PUC Project No. 35077

Second Amendment to the

AMENDED AND RESTATED ERCOT STANDARD GENERATION INTERCONNECTION AGREEMENT

LCRA Transmission Services Corporation, CED Upton County Solar, LLC and VESI Upton County BESS, LLC

One Line Diagram – TSP Interconnection Facilities, Generation Interconnection Facilities and the Plants

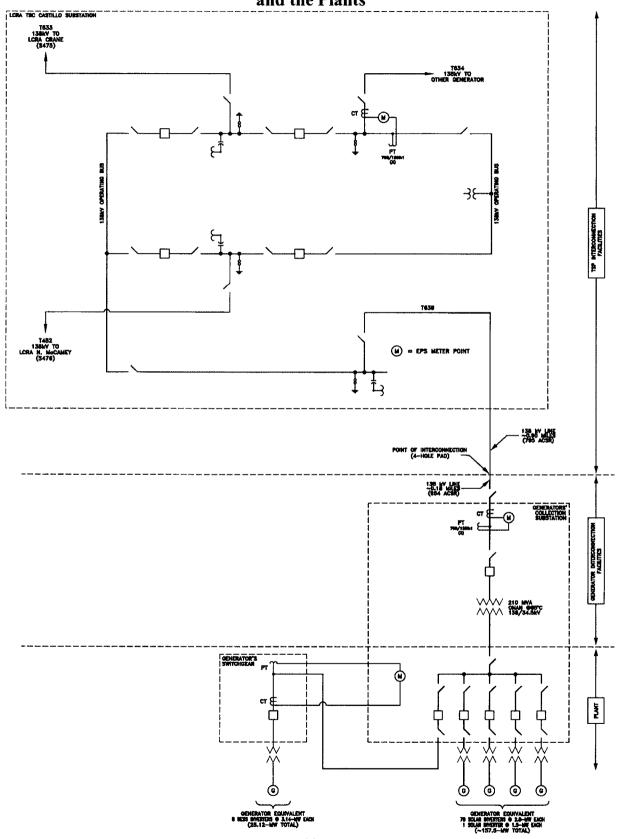
- 1. Article 10.15 of Exhibit "A" to the Agreement is hereby deleted in its entirety and replaced with the following:
 - "10.15 <u>Indemnification and Liability</u>. The indemnification and liability provisions of the PUCT Rule 25.202(b)(2) or its successor shall govern this Agreement."
- 2. Exhibits "B", "C", "C2", and "D" are deleted in their entirety and the Exhibits "B", "C", "C2", and "D" attached to this Second Amendment are hereby added to the Agreement in lieu thereof.
- 3. This Amendment will become effective upon execution by both Parties.
